RBG-46968

SUBJECT: Supplement to Requests for Relief from ASME Section XI Volumetric and Visual Examination Requirements – Second 10-Year Interval
River Bend Station
Docket No. 50-458
License No. NPF-47

**Additional Information for Request for Relief
RBS-ISI-007, RBS-ISI-008, RBS-ISI-009, RBS-ISI-010 and RBS-ISI-011**

RCS-900C-FWB015, RCS-900C-FWB016, RCS-900CX-SW014CB and RCS-900CX-SW014BC
SWEEP-O-LET - TO - PIPE CONFIGURATION AND EXAMINATION COVERAGE

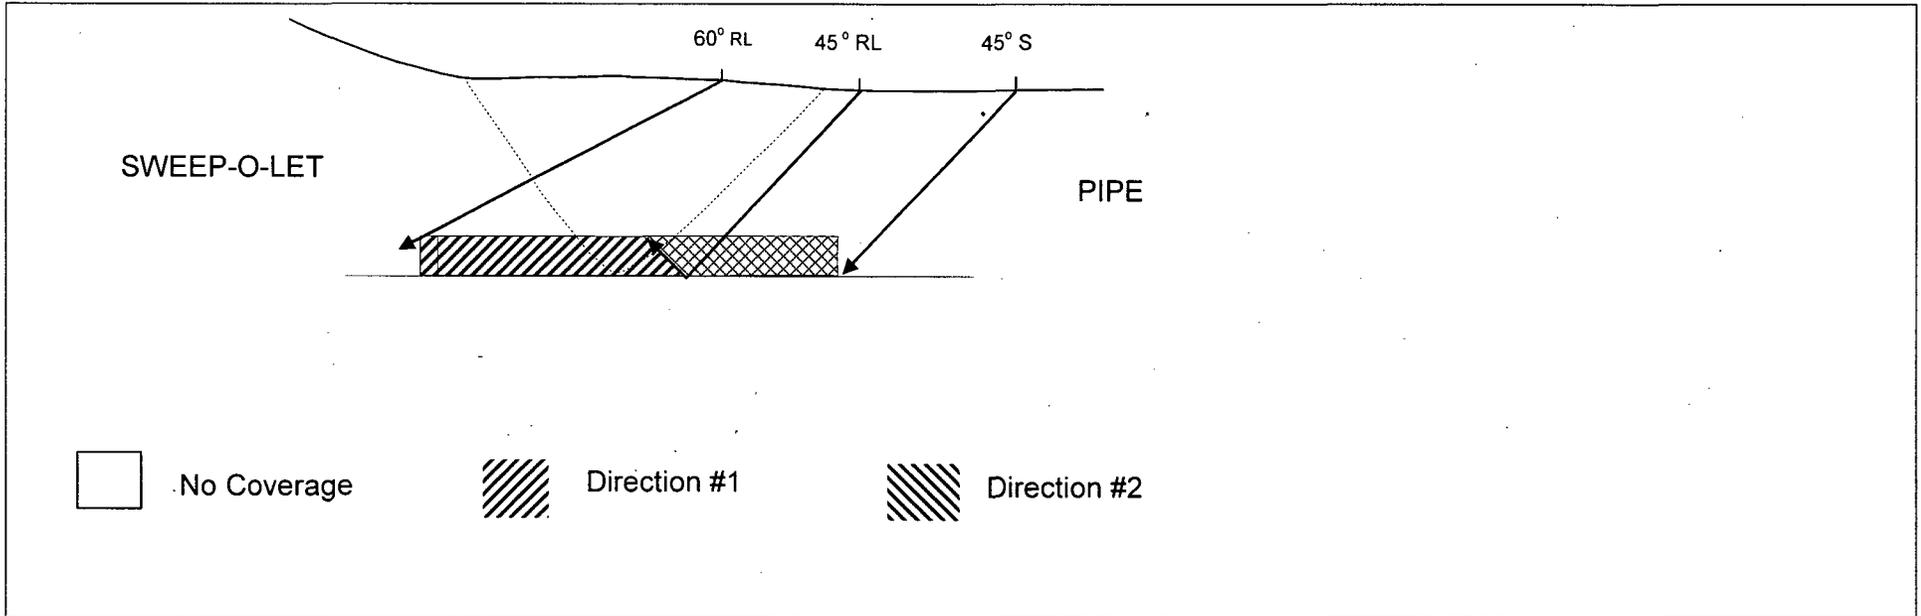
B9.11	RCS-900C-FWB015	Sweep-O-Let to 10" Pipe, SS	85.0%	a) Scanning from pipe side only of pipe-to-sweep-o-let weld configuration. See attached sketches of configurations and scan coverage. b) Subject area scanned manually with KBA and Megasonics search units and Staveley instruments. 100% of the ASME Code Required Volume cannot be examined using manual examination methods. No alternative NDE methods or advanced technologies could be practically employed to maximize ASME Code coverage. Examination performed prior to PDI implementation. c) Modality – Shear and longitudinal. Insonification angles - 45°S and 60°RL. d) See attached Examination Coverage Profile showing the Code Required Volume (CRV). e) Surface examination performed with full code coverage. f) No relevant indications recorded.
B9.11	RCS-900C-FWB016	Sweep-O-Let to 10" Pipe, SS	85.0%	a) Scanning from pipe side only of pipe-to-sweep-o-let weld configuration. See attached sketches of configurations and scan coverage. b) Subject area scanned manually with KBA and Megasonics search units and Staveley instruments. 100% of the ASME Code Required Volume cannot be examined using manual examination methods. No alternative NDE methods or advanced technologies could be practically employed to maximize ASME Code coverage. Examination performed prior to PDI implementation. c) Modality – Shear and longitudinal. Insonification angles - 45°S and 60°RL. d) See attached Examination Coverage Profile showing the Code Required Volume (CRV). e) Surface examination performed with full code coverage. f) No relevant indications recorded.

RBS-ISI-010, B - J Examinations				
Item Number	Item ID	Item Description	% Coverage	Response to NRC Questions
B9.31	RCS-900CX-SW014BC	16" Pipe to Sweep-O-Let, SS	86.0%	a) Scanning from pipe side only of pipe-to-sweep-o-let weld configuration. See attached sketches of configurations and scan coverage. b) Subject area scanned manually with KBA and Megasonics search units and Staveley instruments. 100% of the ASME Code Required Volume cannot be examined using manual examination methods. No alternative NDE methods or advanced technologies could be practically employed to maximize ASME Code coverage. Examination performed prior to PDI implementation. c) Modality – Shear and longitudinal. Insonification angles - 45°S and 60°RL. d) See attached Examination Coverage Profile showing the Code Required Volume (CRV). e) Surface examination performed with full code coverage. f) No relevant indications recorded.

B9.31	RCS-900CX-SW014CB	16" Pipe to Sweep-O-Let, SS	86.0%	a) Scanning from pipe side only of pipe-to-sweep-o-let weld configuration. See attached sketches of configurations and scan coverage. b) Subject area scanned manually with KBA and Megasonics search units and Staveley instruments. 100% of the ASME Code Required Volume cannot be examined using manual examination methods. No alternative NDE methods or advanced technologies could be practically employed to maximize ASME Code coverage. Examination performed prior to PDI implementation. c) Modality – Shear longitudinal. Insonification angles - 45°S and 60°RL. d) See attached Examination Coverage Profile showing the Code Required Volume (CRV). e) Surface examination performed with full code coverage. f) No relevant indications recorded.
B9.11	WCS-001A1-XI-FW005	4" Pipe to valve weld	70.9%	a) Scanning from pipe side only of pipe-to-valve weld configuration. See attached sketches of configurations and scan coverage. b) Subject area scanned manually with KBA search unit and Staveley instrument. 100% of the ASME Code Required Volume cannot be examined using manual examination methods. No alternative NDE methods or advanced technologies could be practically employed to maximize ASME Code coverage. Examination performed prior to PDI implementation. c) Modality – Shear. Insonification angle - 45°S and 70°S. d) See attached Examination Coverage Profile showing the Code Required Volume (CRV). e) Surface examination performed with full code coverage. f) No relevant indications recorded. Root geometry recorded - 360° - outside of weld required volume.

WCS-001A3-XI-FW011
REDUCER-TO-PIPE CONFIGURATION AND EXAMINATION COVERAGE

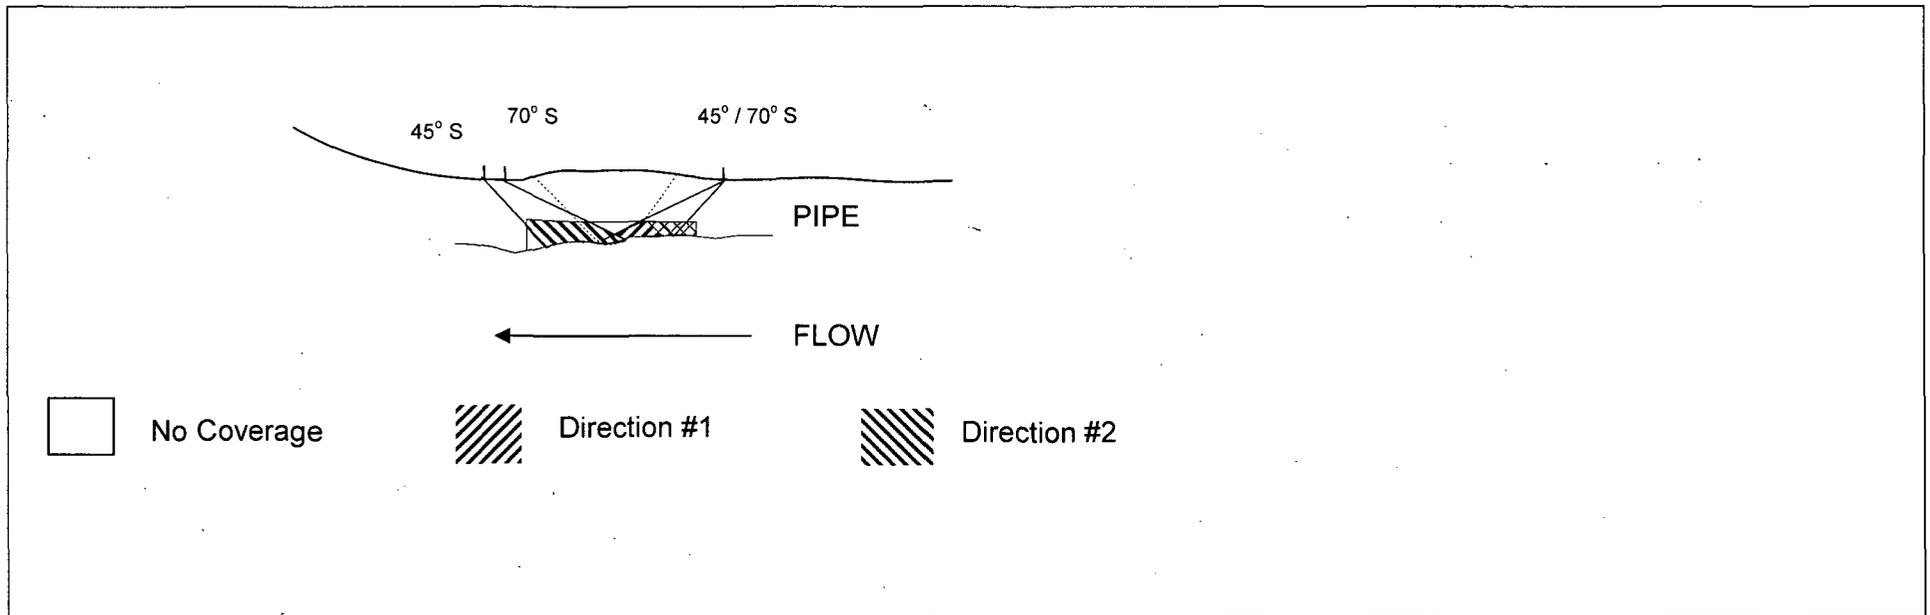
Item Number	Item ID	Item Description	% Coverage	Response to NRC Questions
B9.11	WCS-001A3-XI-FW011	4" Pipe to reducer weld	79.0%	a) Scanning from reducer side of pipe-to-reducer weld limited due to weld crown configuration. See attached sketches of configurations and scan coverage. b) Subject area scanned manually with KBA search unit and Staveley instrument. 100% of the ASME Code Required Volume cannot be examined using manual examination methods. No alternative NDE methods or advanced technologies could be practically employed to maximize ASME Code coverage. Examination performed prior to PDI implementation. c) Modality – Shear. Insonification angles - 45°S and 70°S. d) See attached Examination Coverage Profile showing the Code Required Volume (CRV). e) Surface examination performed with full code coverage. f) No relevant indications recorded.
B9.11	WCS-005A-XI-SW002	6" Pipe to tee	80.5%	a) Scanning from tee side, only ~ 60% of circumference of pipe-to-tee weld accessible due to fitting configuration. See attached sketches of configurations and scan coverage. b) Subject area scanned manually with KBA and RTD search units and Staveley instrument. 100% of the ASME Code Required Volume cannot be examined using manual examination methods. No alternative NDE methods or advanced technologies could be practically employed to maximize ASME Code coverage. Examination performed after PDI implementation with Appendix VIII qualified procedures. c) Modality – Shear and longitudinal. Insonification angles - 45°S, 60°S and 60°L. d) See attached Examination Coverage Profile showing the Code Required Volume (CRV). e) Surface examination performed with full code coverage. f) No relevant indications recorded.

WCS-005A-XI-SW002, WCS-001A3-XI-SW002
PIPE-TO-TEE CONFIGURATION AND EXAMINATION LIMITATIONS

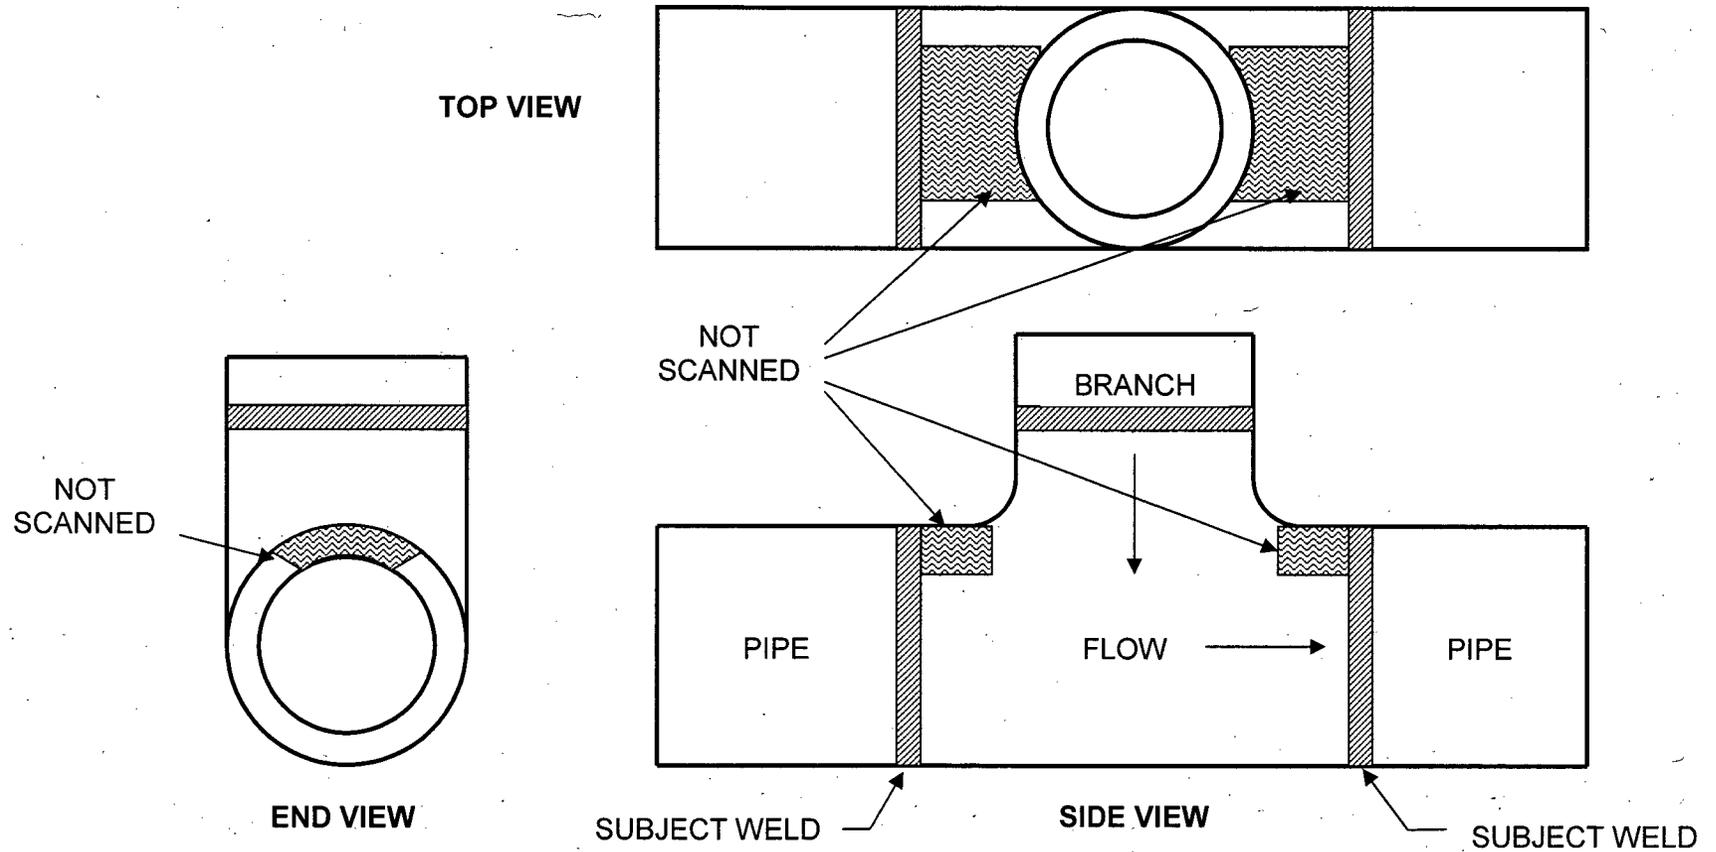
RBS-ISI-010, B - J Examinations				
Item Number	Item ID	Item Description	% Coverage	Response to NRC Questions
B9.11	WCS-001A3- XI-SW002	6" Pipe to tee	80.5%	<p>a) Scanning from tee side, only ~ 60% of circumference of pipe-to-tee weld accessible due to fitting configuration. See attached sketches of configurations and scan coverage.</p> <p>b) Subject area scanned manually with KBA and RTD search units and Staveley instrument. 100% of the ASME Code Required Volume cannot be examined using manual examination methods. No alternative NDE methods or advanced technologies could be practically employed to maximize ASME Code coverage. Examination performed after PDI implementation with Appendix VIII qualified procedures.</p> <p>c) Modality – Shear and longitudinal. Insonification angles - 45°S, 60°S and 60°L.</p> <p>d) See attached Examination Coverage Profile showing the Code Required Volume (CRV).</p> <p>e) Surface examination performed with full code coverage.</p> <p>f) No relevant indications recorded.</p>

WCS-005A-XI-SW003
TEE-TO-BRANCH CONFIGURATION AND EXAMINATION LIMITATIONS

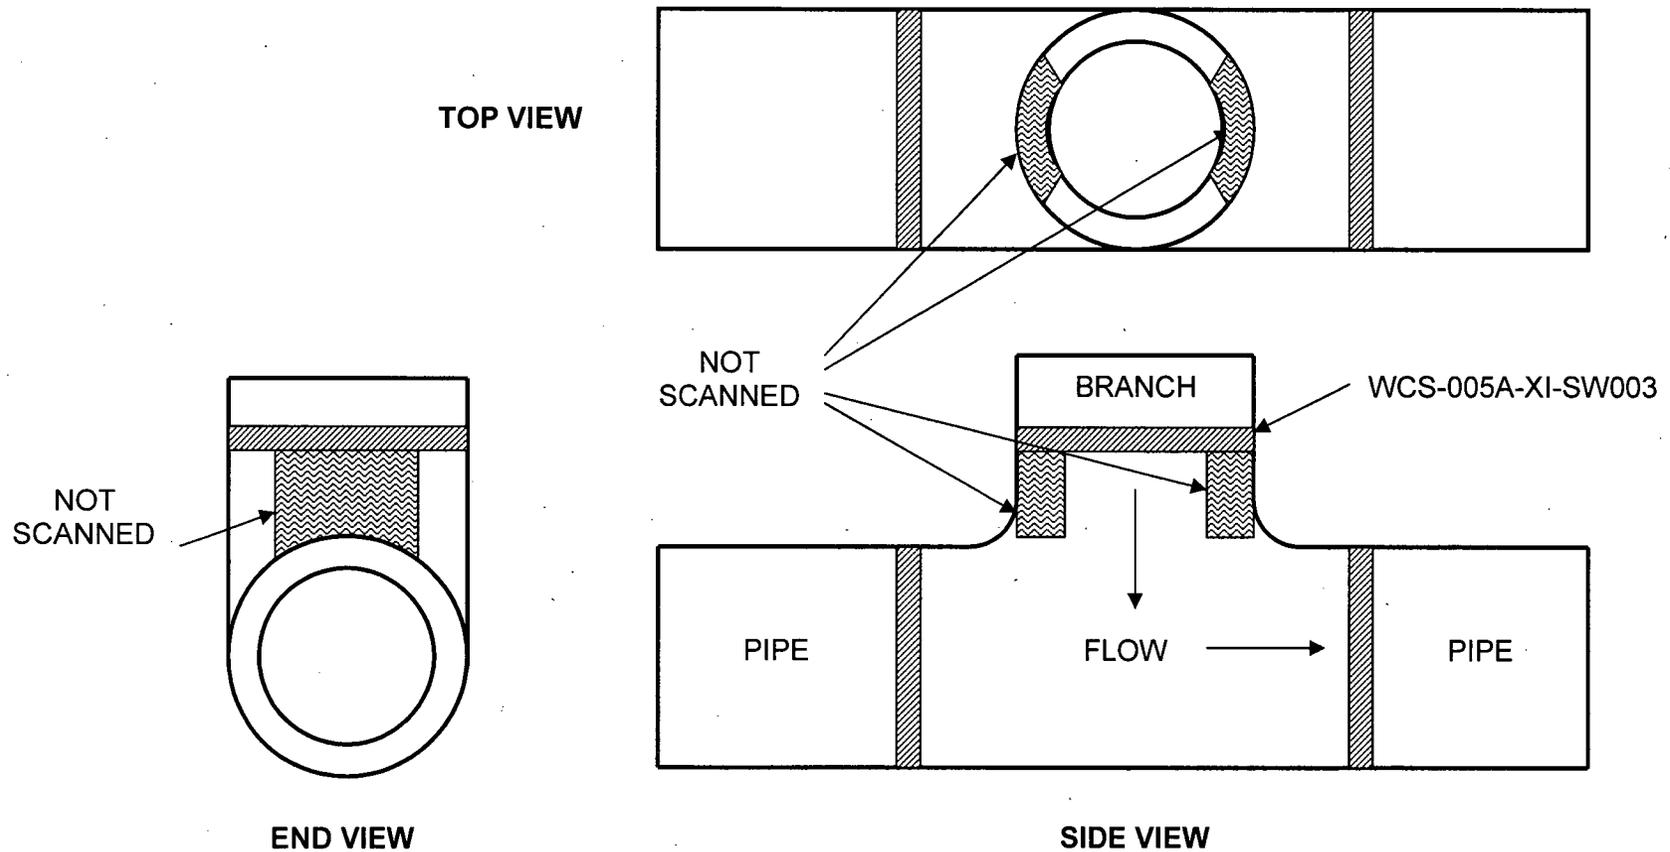
B9.11	WCS-005A-XI-SW003	6" Tee to branch	77.3%	a) Scanning from tee side, only ~ 55% of circumference of pipe-to-tee weld (at branch) accessible due to fitting configuration. See attached sketches of configurations and scan coverage. b) Subject area scanned manually with KBA and RTD search units and Staveley instrument. 100% of the ASME Code Required Volume cannot be examined using manual examination methods. No alternative NDE methods or advanced technologies could be practically employed to maximize ASME Code coverage. Examination performed after PDI implementation with Appendix VIII qualified procedures. c) Modality – Shear and longitudinal. Insonification angles - 45°S, 60°S and 60°L. d) See attached Examination Coverage Profile showing the Code Required Volume (CRV). e) Surface examination performed with full code coverage. f) No relevant indications recorded.
